## 30. Management

### 30.15 Layer management for Single-pair Power over Data Lines (PoDL)

## 45. Management Data Input/Output (MDIO) Interface

**Figure 30-3— DTE System entity relationship diagram**

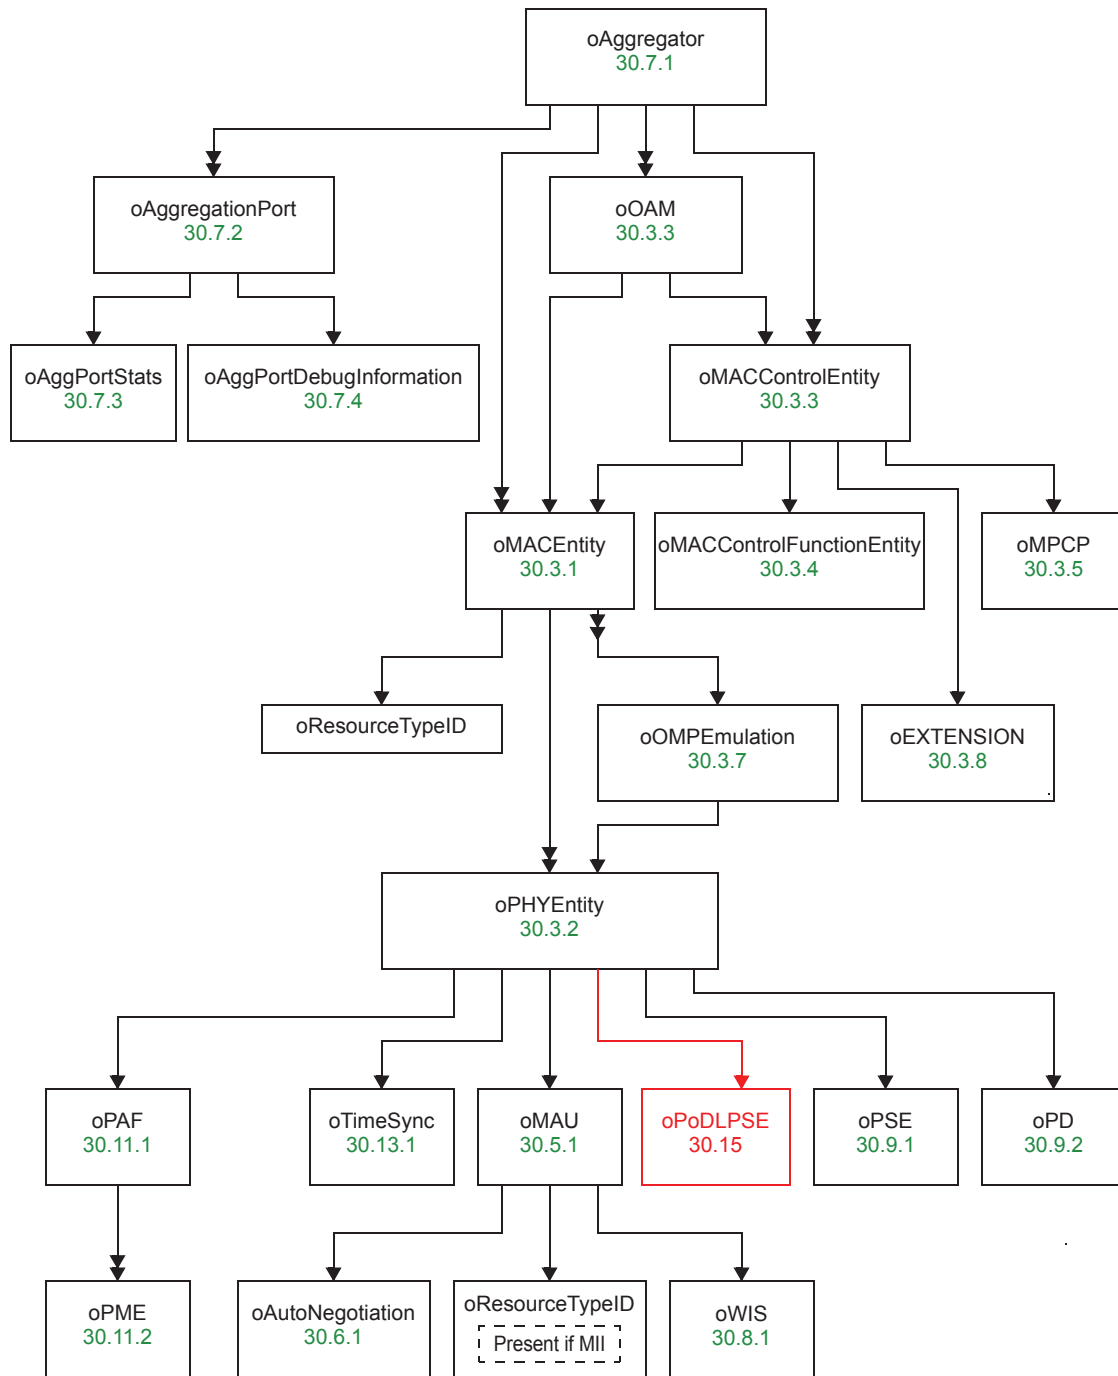
Change Figure 30-3 by adding oPoDLPSE entity as shown in red below:
